Transport Comments on Hamner Springs 'Flyride' Parking Assessment

Prepared for: Hurunui District Council
Job Number: HRNDC-J005
Revision: Final
Issue Date: 15 September 2021
Prepared by: Dave Smith, Technical Director

Figure 4 Minimum carriageway width from FENZ guidelines (fig 1)

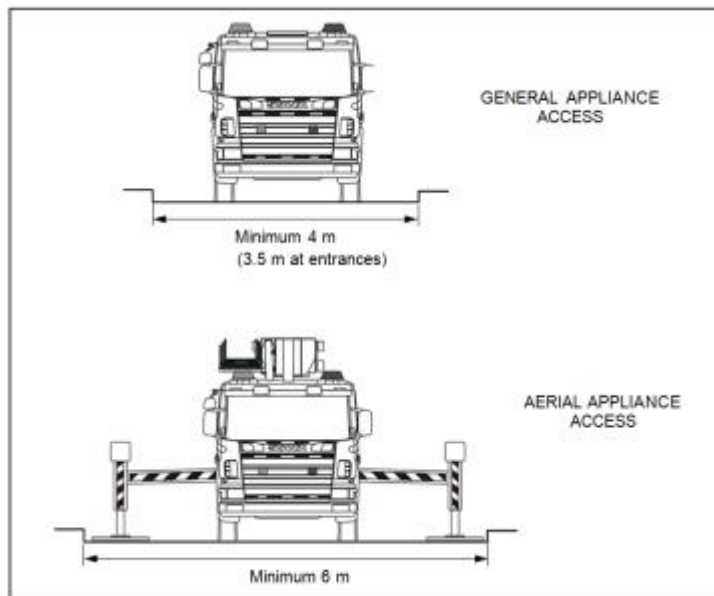
53. The 85th%ile vehicle width in the Australian New Zealand Standard (ASNZS) 2890.2004 is 1.87m but acknowledging that vehicle may not park flush with the curve I consider that an 8m wide corridor is required to provided sufficient clearance for Fire and Emergency vehicles if cars are parked on both sides of the corridor.

54. I have undertaken measurements using online aerial photography and established that the existing carriageway widths on Conical Hill Road, Thomas Hanmer Drive, and Chalet Crescent are greater than 8m. The local roads where cars associated with the Flywire may park on both sides of the road which are deficient are Oregon Heights and Acheron Heights, where I have measured the carriageway widths to generally be between 7.2m and 7.8m. I note that Oregon Heights has No Stopping At All Times (NSAAT) lines installed on the south side of the corridor however if vehicles were parked on both sides of Acheron Heights this would leave less than 4m clear for emergency vehicles.

56. The narrow road width and parking demands are clearly an existing issue restricting access to emergency vehicles however I note the Novo Group survey only identified four vehicles parked on Acheron Heights. I intend to undertake my own observations prior to the hearing to better understand the parking demand at this location and extent to which emergency vehicle access may be compromised.

57. However, I consider that this is an issue which may be exacerbated by additional parking demand associated with the Flyride activity. Given this increased risk, it is recommended that the parking monitoring proposed be extended to Acheron Heights to ensure that vehicles associated with the activity are not encroaching beyond the cul-de-sac head along both sides of the corridor. Should this be the case then it is recommended that wayfinding be installed to reinforce that access to the Flyride activity is via Conical Hill Road. If this were the case I would further recommend that parking is restricted to one side of the road on Acheron Heights although I note this is a matter for the Community Board and not for the applicant.

- b. Monitoring should extend to the extent of parking associated with the activity on Acheron Heights. Should parking demand extend to both sides of the corridor such that vehicles potentially impede Emergency and Fire Appliances access then the applicant should work with Council to install No Stopping At All Times (NSAAT) markings on one side of Acheron Heights or agree on other suitable mitigation including the implementation of wayfinding.
